**PREVOST****BULLETIN
DE
GARANTIE**

Bg08-13

DATE : JUILLET 2008	SECTION : 06 - Électricité
EXPIRATION: JUILLET 2010	
SUJET : REMPLACEMENT DE L'INTERRUPTEUR DE RÉGÉNÉRATION STATIONNAIRE DU TABLEAU DE BORD – MOTEUR DETROIT DIESEL SÉRIE 60

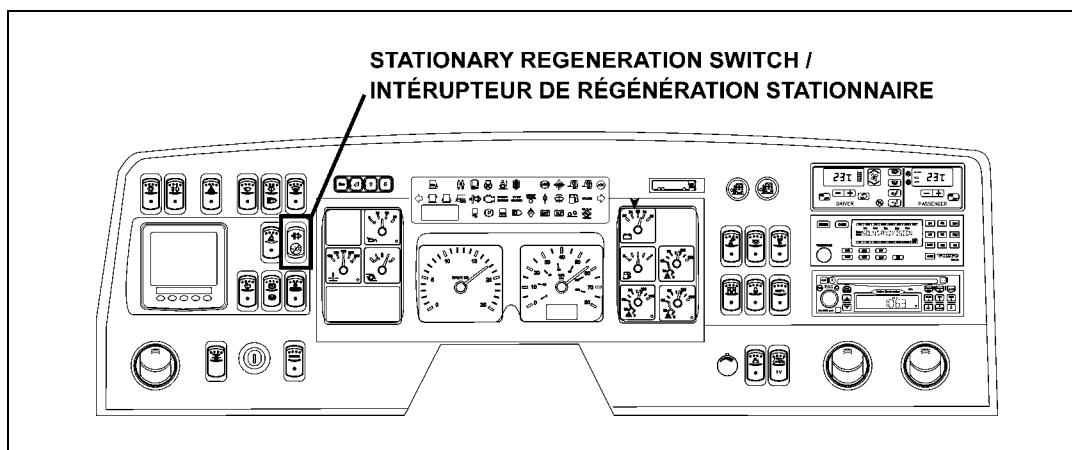
Sur les véhicules ci-haut mentionnés, il est **absolument nécessaire** de remplacer l'interrupteur de régénération stationnaire situé sur le tableau de bord, à défaut de quoi, il sera impossible d'enclencher une régénération, suite à une mise à jour de la programmation du système de contrôle DDEC VI de Detroit Diesel. Noter que ce remplacement est nécessaire seulement pour les véhicules munis d'un moteur Detroit Diesel Série 60.

Il est impératif que l'interrupteur soit remplacé AVANT que le véhicule soit amené chez un distributeur Detroit Diesel pour une mise à jour de la programmation DDEC VI. Si la mise à jour est faite avant le remplacement de l'interrupteur de régénération stationnaire, celui-ci ne sera plus fonctionnel.

Pièce No	Description	Qté
564106	Interrupteur de régénération stationnaire	1

Avant de retirer l'interrupteur en place, vérifiez-en le numéro de pièce Prevost sur l'étiquette apposée sur le boîtier de l'interrupteur. Si il est indiqué 564106, il s'agit du nouvel interrupteur et celui-ci n'a pas besoin d'être changé.

2. Débrancher le connecteur de l'interrupteur actuellement en place.
3. Par l'arrière du tableau de bord, pincer les pattes de retenue de l'interrupteur actuellement en place et retirer l'interrupteur. Celui-ci sortira par l'avant du tableau de bord.
4. Insérer le nouvel interrupteur puis brancher le connecteur.
5. Remettre le couvercle du tableau de bord en place.
